# REPORT TO PLANNING COMMISSION City of Sacramento

**Subject: Swanston Station Transit Village Specific Plan (M09-020)**

- A. Environmental Determination: Environmental Impact Report (EIR);
- B. Mitigation Monitoring Plan;
- C. Swanston Station Transit Village Specific Plan
- D. Rezone various parcels in the Swanston Station Transit Village Specific Plan Area.

Attachment: Dry Creek Interceptor Plan and Profile Sheet 8

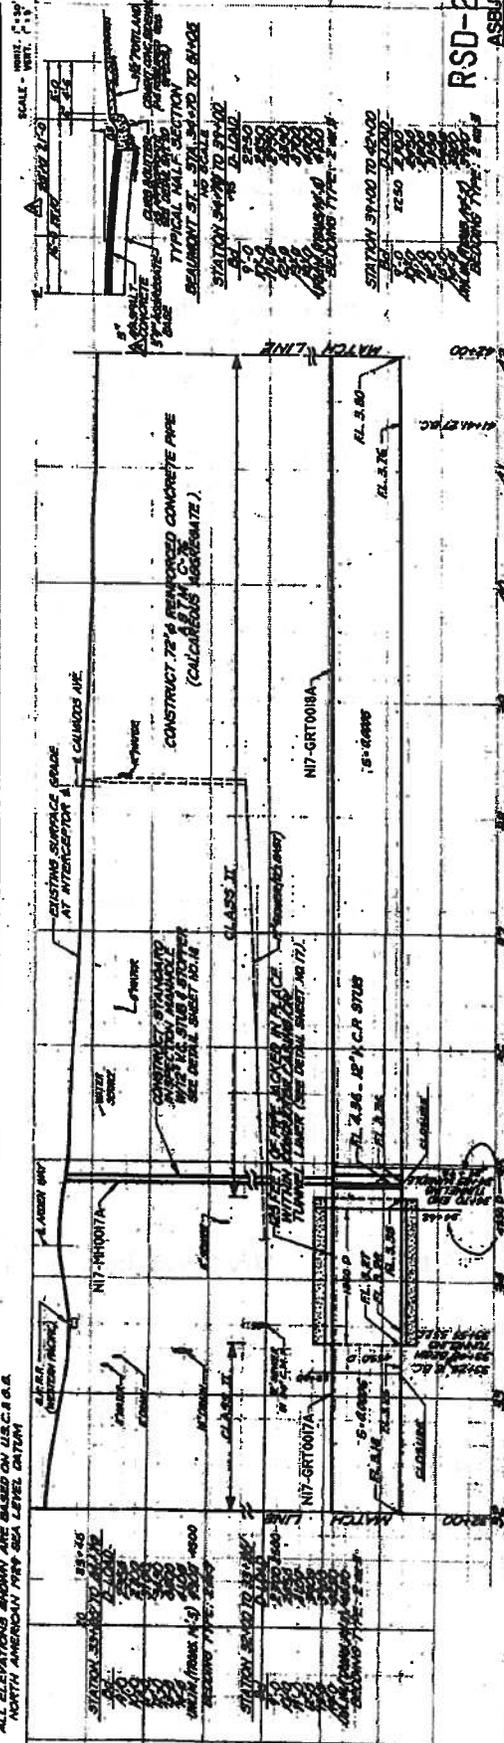
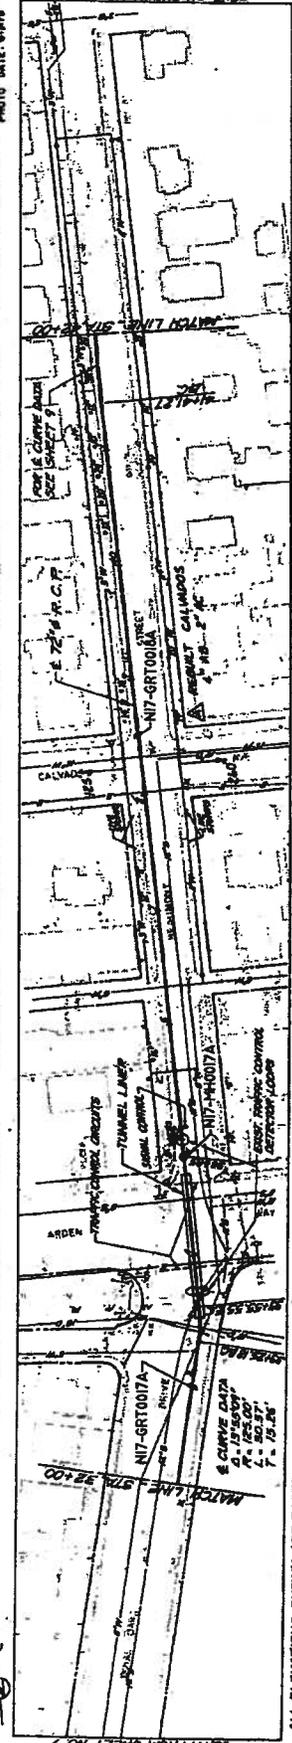
If you have any questions regarding these comments please feel free to contact me at (916) 876-5608, or by e-mail at [obonel@sacsewer.com](mailto:obonel@sacsewer.com). Attached for your reference is the as-built for the 72-inch Dry Creek Interceptor.

2.1 As noted by the commenter, Figure 2-14 (Proposed Water System Improvements) shows an existing 6-inch water main with the Beaumont Street right-of-way that would be improved to 8 inches to satisfy the City's minimum standards. The commenter reports that the 72-inch Dry Creek interceptor also lies within that right-of-way. Future plans to improve the water line will be closely coordinated with the District to ensure minimal conflicts with the Dry Creek interceptor.

2.3 As noted by the commenter, Figure 2-15 (Proposed Sanitary System Improvements) shows an existing 12-inch wastewater line with the Beaumont Street right-of-way that would be improved to 18 inches to meet future wastewater flows. The commenter reports that the 72-inch Dry Creek interceptor also lies within that right-of-way. Future plans to improve the wastewater line will be closely coordinated with the District to ensure minimal conflicts with the Dry Creek interceptor.
